**From:** Katanic, Janine  
**Sent:** Monday, August 24, 2015 7:18 AM  
**To:** Munoz, Rick  
**Subject:** FW: Chevron Deepwater Projects and Exploration, OCS-G 20082 PS009 ST00BP00 Abandonment

**From:** Timothy McLaughlin [<mailto:mclaughlin8@slb.com>]  
**Sent:** Friday, August 21, 2015 4:22 PM  
**To:** Whitten, Jack; HOO Hoc  
**Cc:** Chuck Deible  
**Subject:** [External\_Sender] Chevron Deepwater Projects and Exploration, OCS-G 20082 PS009 ST00BP00 Abandonment  
**Importance:** High

<b>Licensee</b>	Schlumberger Technology Corporation (License# 42-00090-03)
<b>Company Name</b>	Chevron Deepwater Projects and Exploration
<b>Well Name</b>	OCS-G 20082 PS009 ST00BP00 (Green Canyon 640)
<b>API Number</b>	608114064800
<b>Total Depth</b>	27,250 ft MD

DC3-G 20082 P3009 ST00BP00

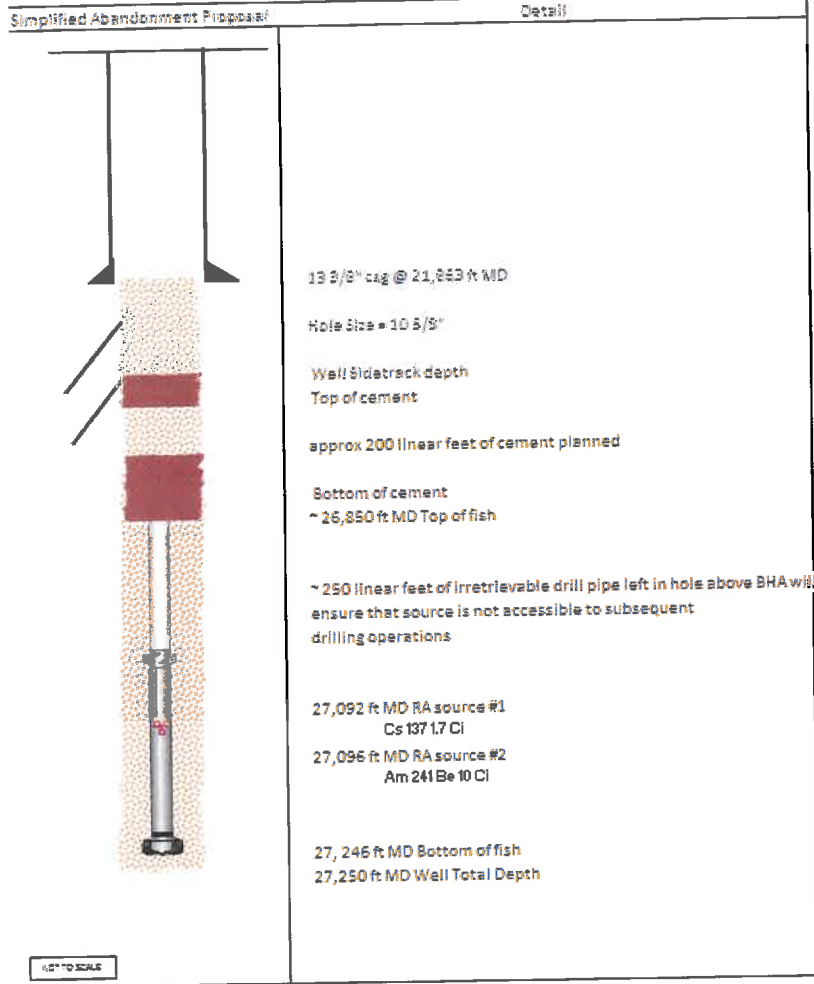
The top source is stuck at approximately 27,092 ft MD and the top of fish (TOF) is not yet established but estimated to be 250 linear feet above the top source @ 26,850 ft MD. Therefore, the irretrievable bottom hole assembly (BHA) will consist of at least 250 linear feet of drill pipe along with other BHA components and will ensure that the sources are not accessible to future drilling operations. The rig will attempt to set a cement plug of at least 200 linear ft above the top of fish. This will seal and isolate the sources in place. A second cement plug may then be set further up the hole, and the rig will drill through this plug to side track the well.

Based on the information provided in your proposed abandonment procedures, and the telephone call that I participated on the HOO Bridge, you are hereby authorized to proceed with the proposed abandonment. Should additional complications arrive, please contact the NRC HOO with any modifications to the proposed procedures and the will patch me into the telephonic decision making bridge.
